Sweet Cherry Pie

Artform Home Plans
AFHP Design # 481.124.v2 KR
© 2012-2018 Art Form Architecture 603.431.9559
Sweet Cherry Pie
Lot 29 Stroudwater Preserve
Portland, ME
1
1/4"=1'-0" unless noted otherwise / Print @ 1:1
PDF created on: 7/19/2018, drawn by ACJ
Issued for: **Construction**

DRAWING NAME: SITE PLAN
 PROJECT NAME: LOT 29 LEVEL I MINOR RESIDENTIAL APPLICATION
 STROUDWATER PRESERVE
 CLIENT: STROUDWATER DEVELOPMENT PARTNERS, LLC
 KENNEBUNK, ME

First Floor Plan
Living Area this Floor: 946 sq ft
8'-0" Finished Ceiling Height

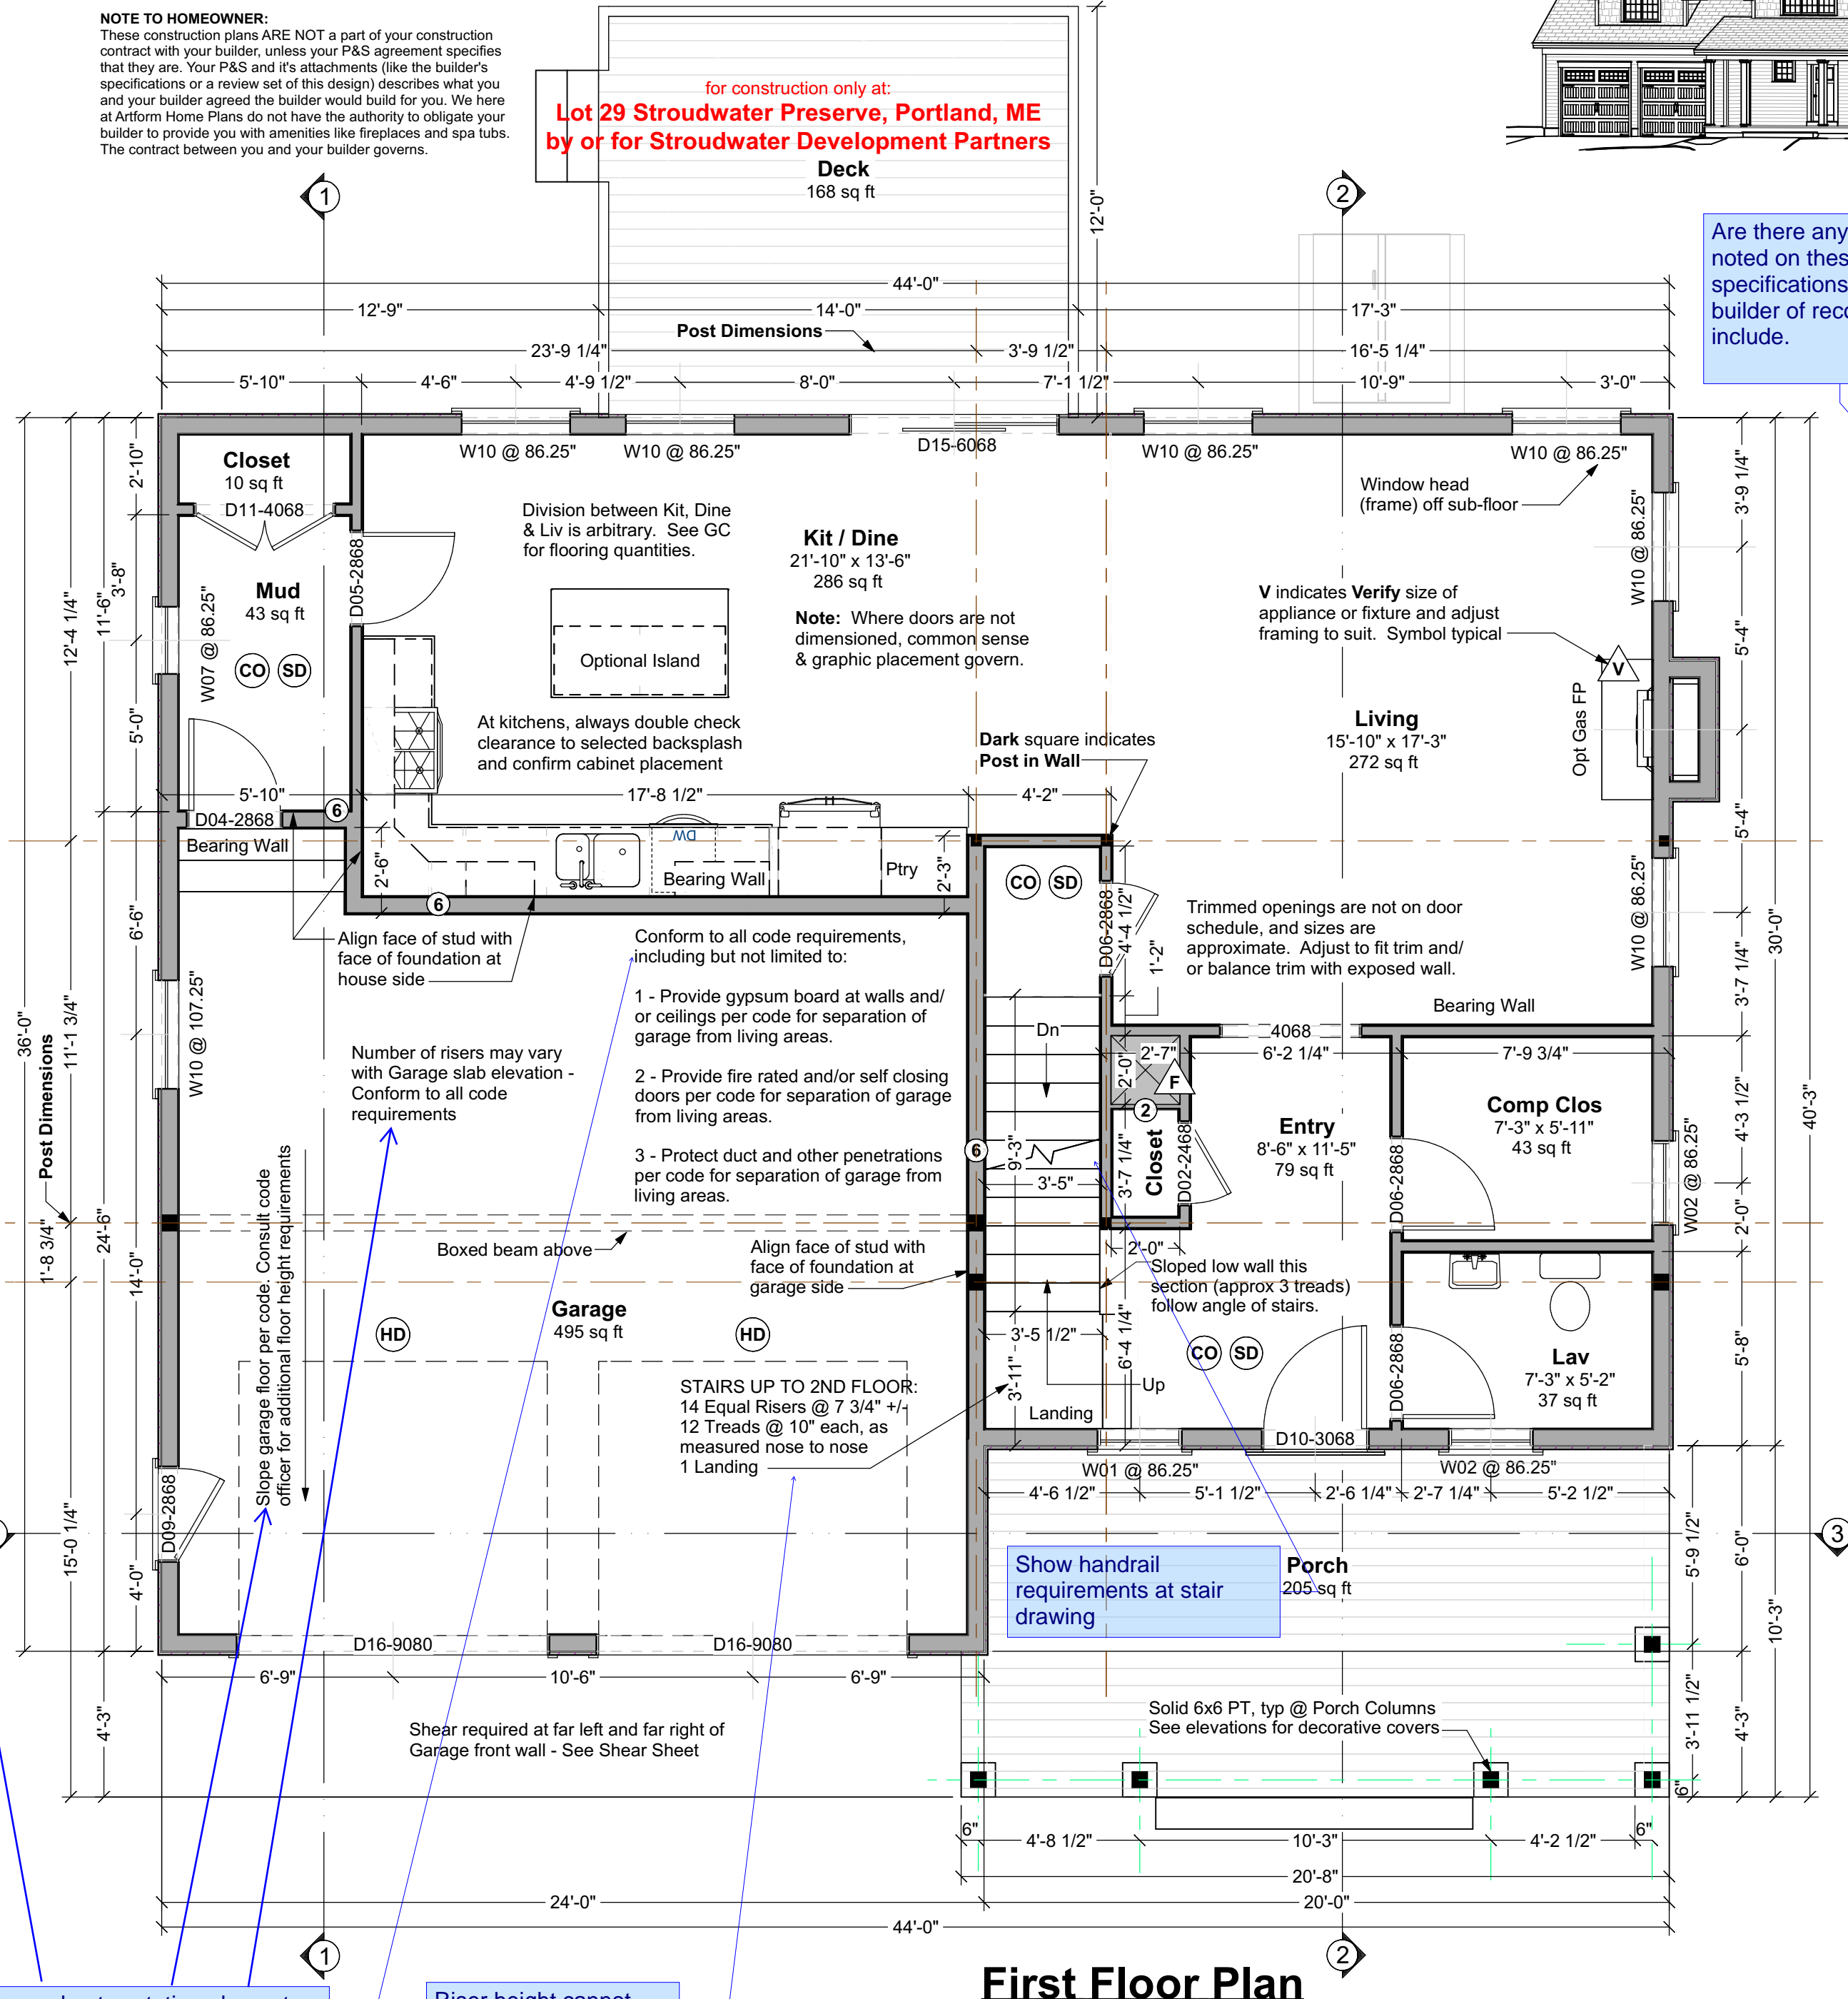
Are there any changes noted on these plans and specifications per the builder of record? Please include.

General notes stating elements will be to code are insufficient. Specific information relevant to this dwelling unit/site is required.

Riser height cannot exceed 7 3/4". Please show actual riser height for this stair.

Indicate a minimum 13D sprinkler protection system to be installed

Foundation Plan

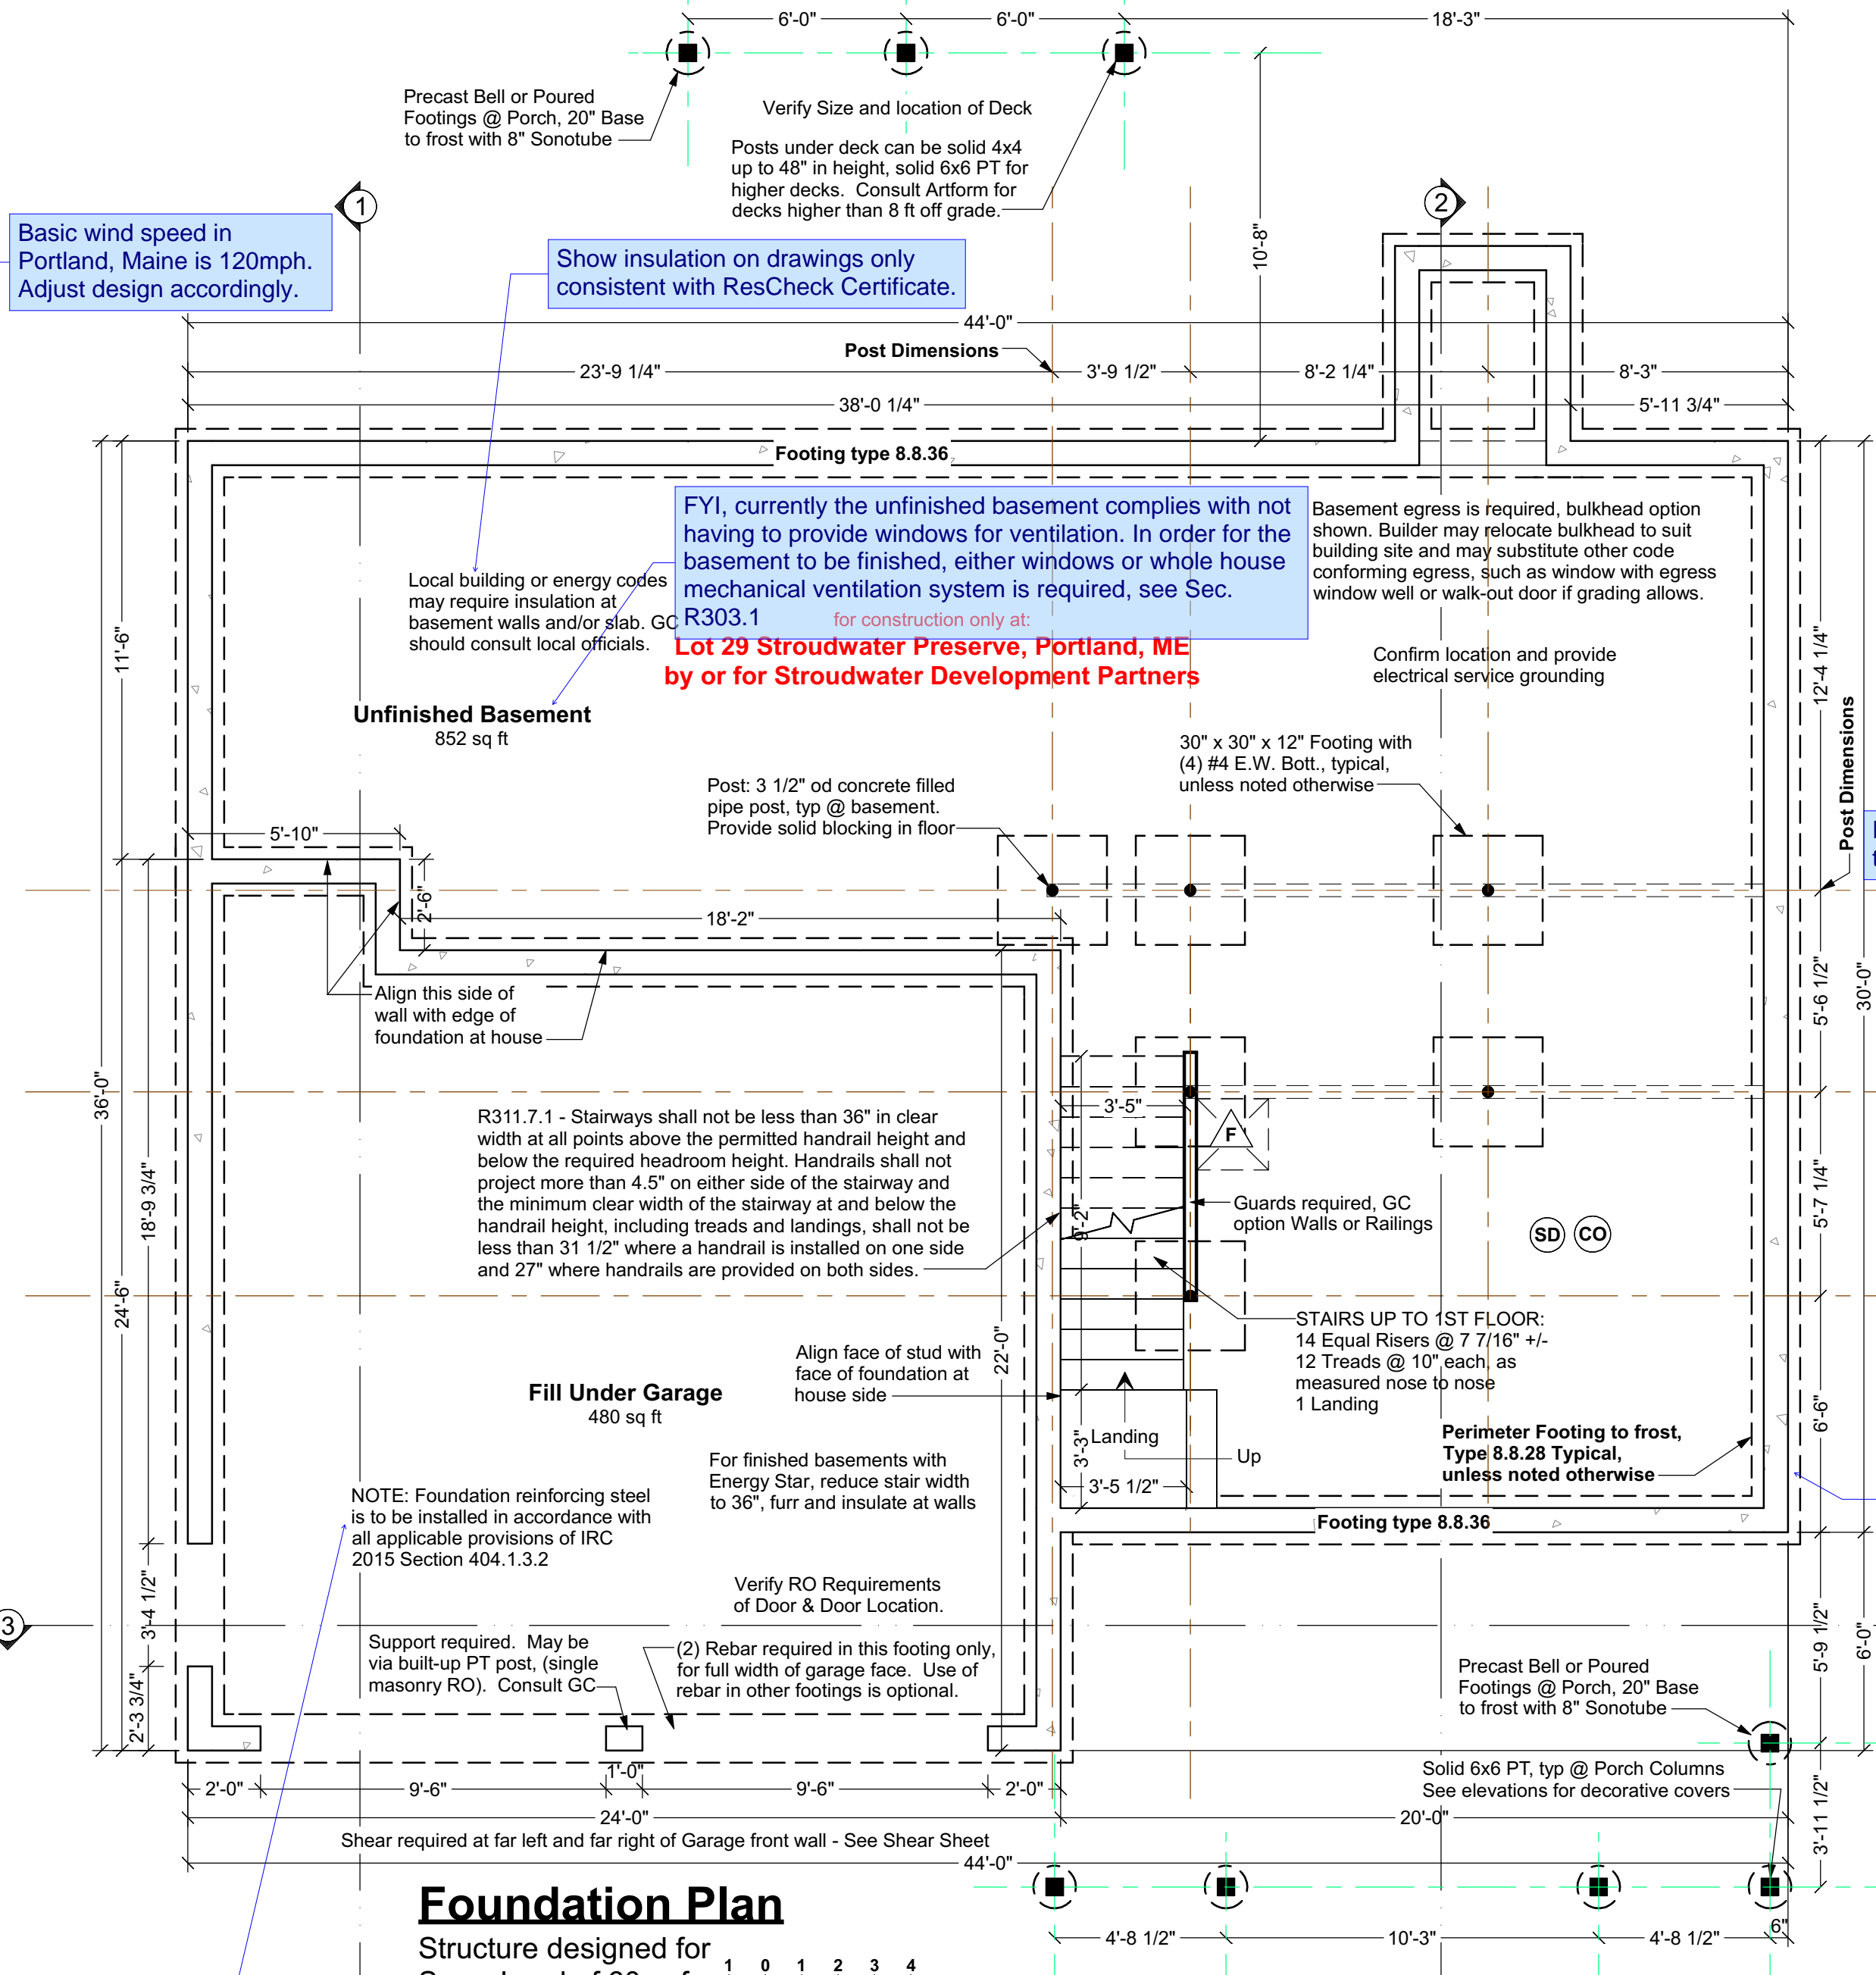
General notes stating elements will be to code are insufficient. Specific information relevant to this dwelling unit/site is required.

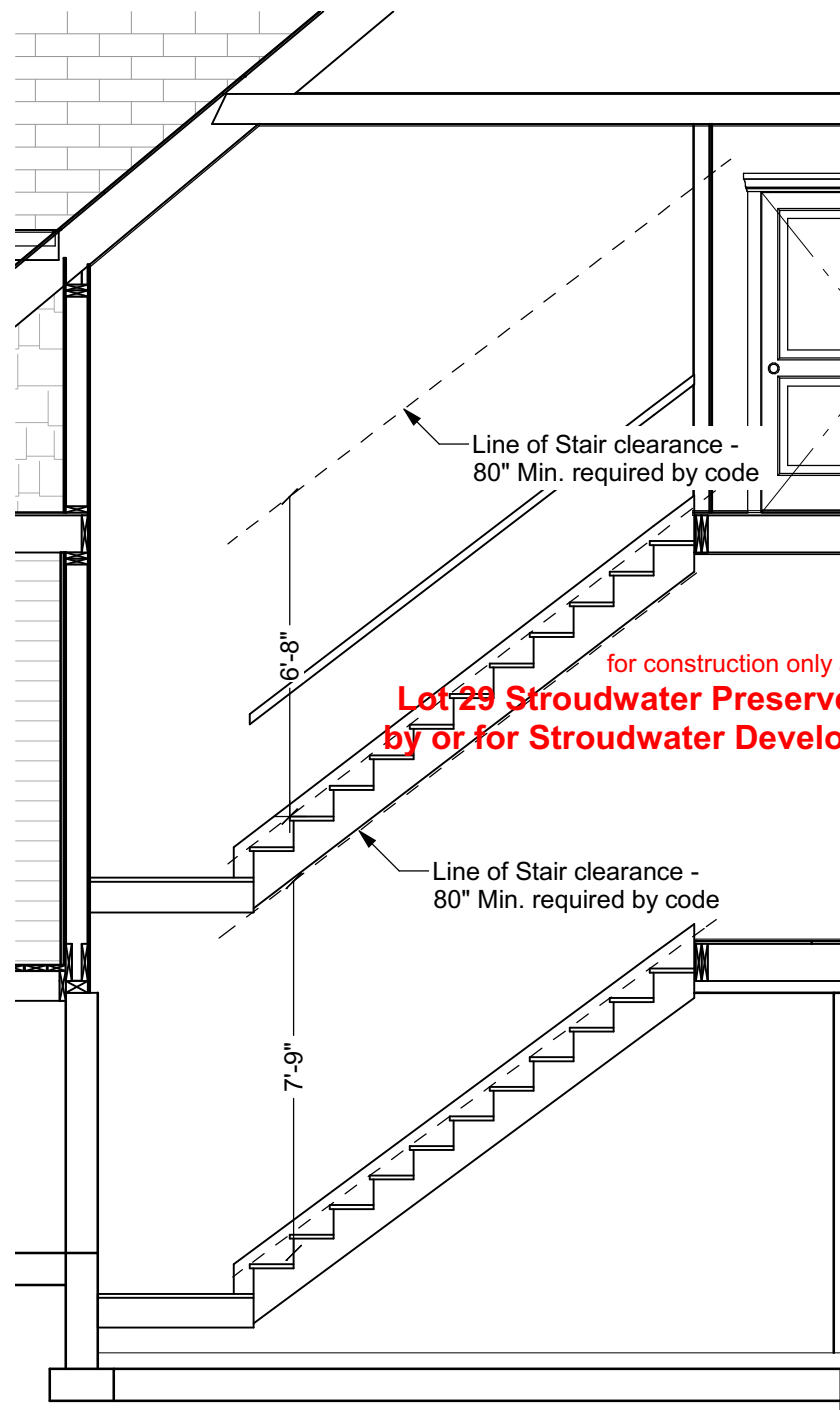
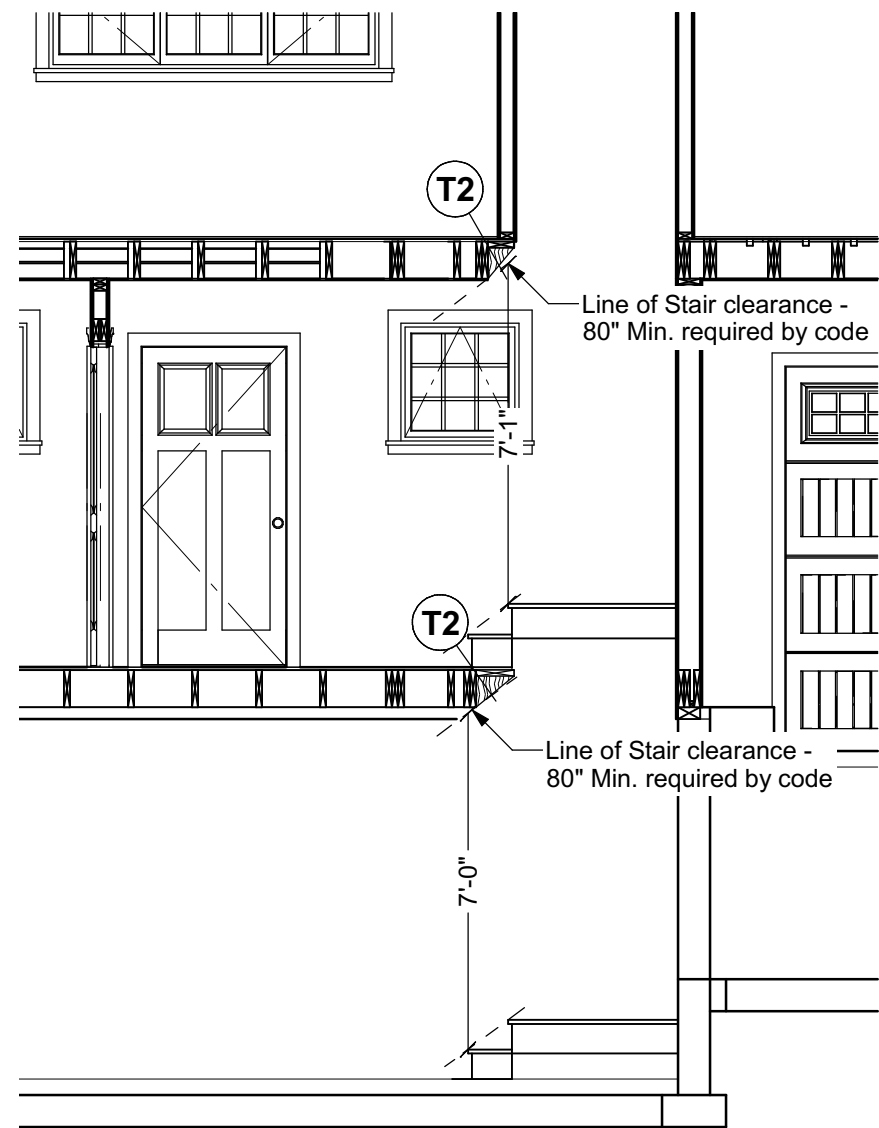
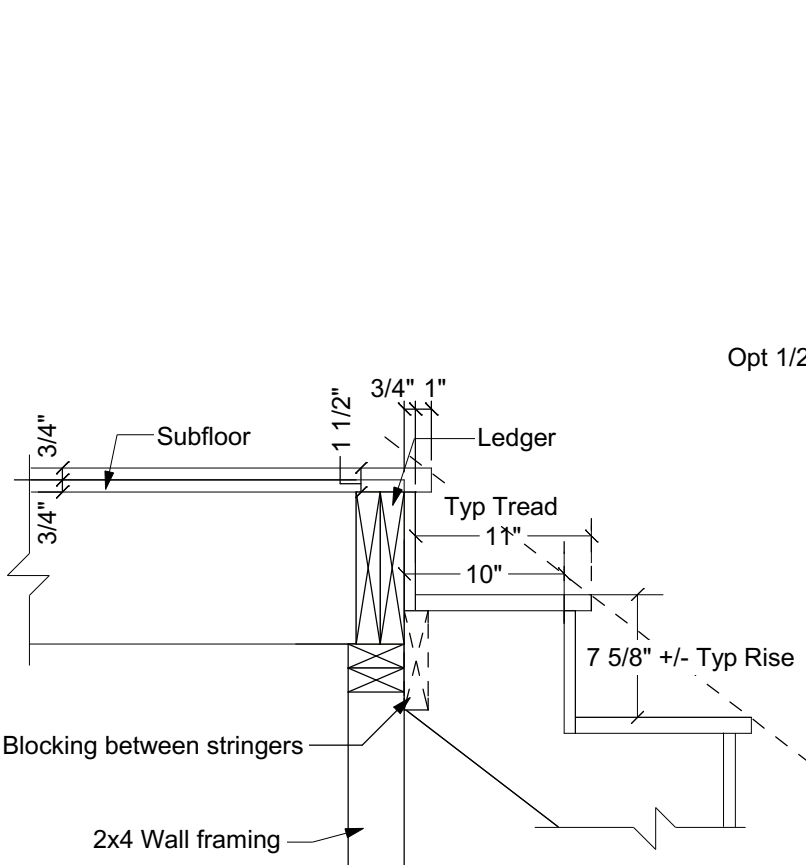
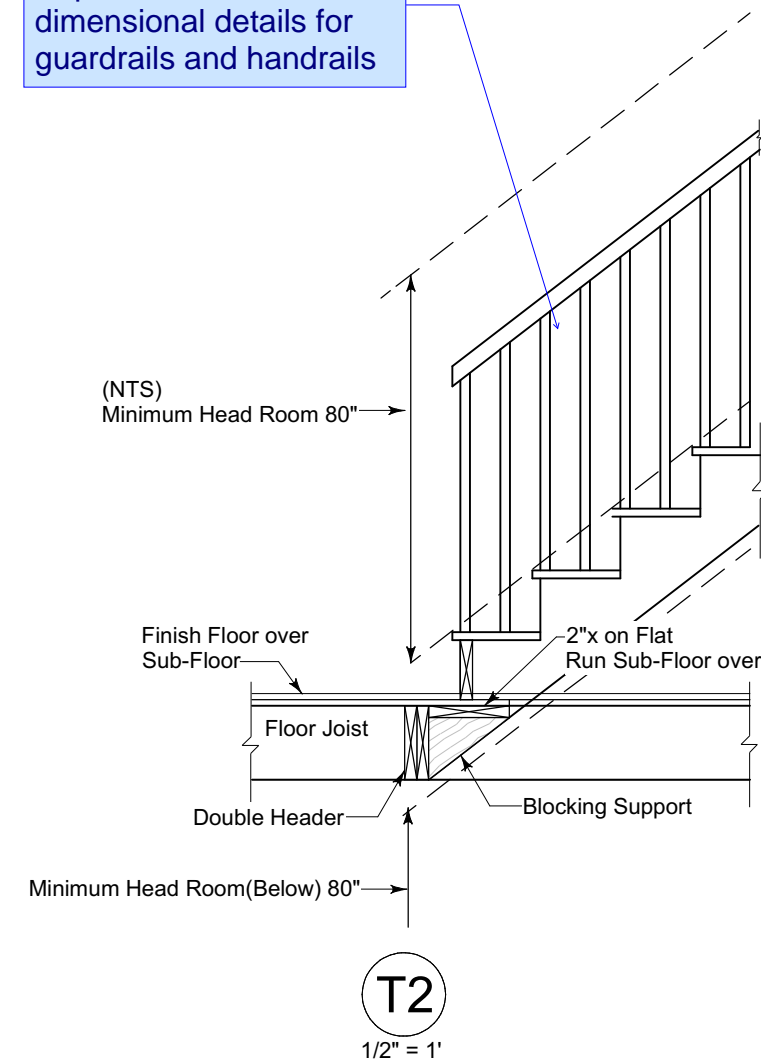
Provide code specific requirements and dimensional details for guardrails and handrails
